Synthetic Review Drawing Stub

Part	Hot-melt glue nozzle mount bracket
Revision	B
Pilot	SOMIC
Material	Stainless 304

Views

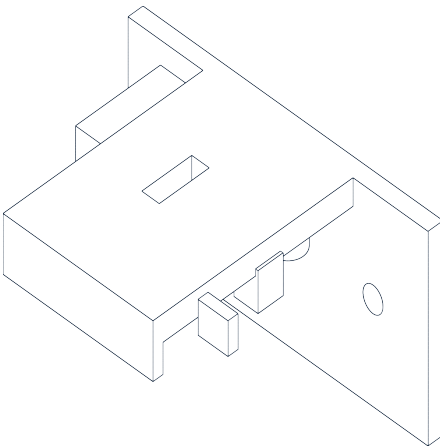
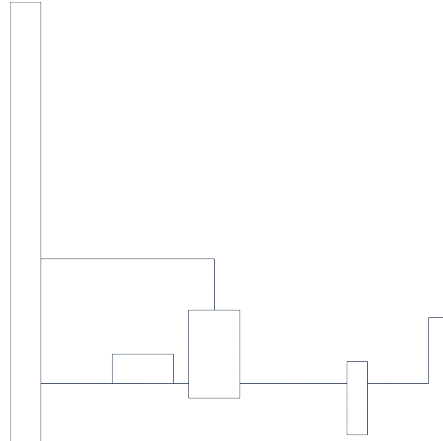
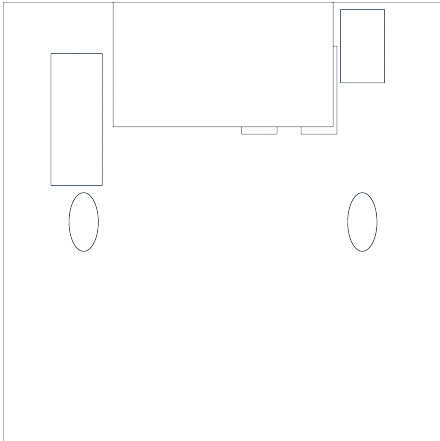
- Add a stiffening rib after vibration drift appears at higher throughput.
- Narrow and tighten the process-adjustment slot.
- Keep the nozzle mounting envelope constant while strengthening the bracket.
